Access Compliance Report

Public Rights-of-Way

(Curb Ramps)

Intersection ID: 12080	Main Street: E_15TH_ST	Cross Street: SEIGLE_AV	Location: W
ADA ID: 03EDC675F00A	Ramp Type: Perp	Initial Pass/Fail: Fail	Overall Compliance: No
Severity Score: 8.75			
Codes/Mitigation Info/Possible Solution		Field Measurements/Component Compliance

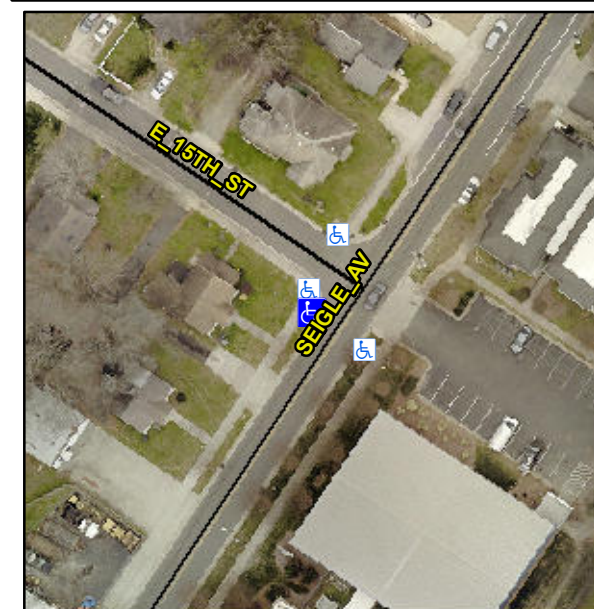
Not Found, R304.5.1

Compliance	Description	Data	Compliance	Description	Data
N/A	Ramp Length (in)	61.0	Yes	Ramp Slope (%)	5.0
No	Ramp Width (in)	47.5	Yes	Ramp XSlope (%)	1.3
N/A	Flare Type LT	N/A	N/A	Flare Type RT	N/A
N/A	Flare Slope LT (%)	N/A	N/A	Flare Slope RT (%)	N/A
N/A	Flare Traversable LT?	N/A	N/A	Flare Traversable RT?	N/A
N/A	Landing Length (in)	N/A	N/A	DWS Provided?	N/A
N/A	Landing Width (in)	N/A	N/A	DWS Contrast?	N/A
N/A	Landing Slope (%)	N/A	N/A	DWS Length (in)	N/A
N/A	Landing X Slope (%)	N/A	N/A	DWS Full Width?	N/A
N/A	Landing Curb? (Y/N)	N/A	N/A	DWS Offset (in)	N/A
N/A	Shared Landing?	N/A			
N/A	Gutter Ponding?	N/A	N/A	Gutter Slope (%)	N/A
N/A	Gutter Lip Ht (in)	N/A	N/A	Gutter X Slope (%)	N/A
N/A	Painted X Walk1?	No	N/A	Painted X Walk2?	N/A
	X Walk 1 Direction	To SE		X Walk 2 Direction	N/A
N/A	X Walk 1 Width (in)	N/A	N/A	X Walk 2 Width (in)	N/A
	X Walk 1 Slope (%)	0.9		X Walk 2 Slope (%)	N/A
	X Walk 1 X Slope (%)	1.6		X Walk 2 X Slope (%)	N/A

Remove & Replace Entire Ramp.
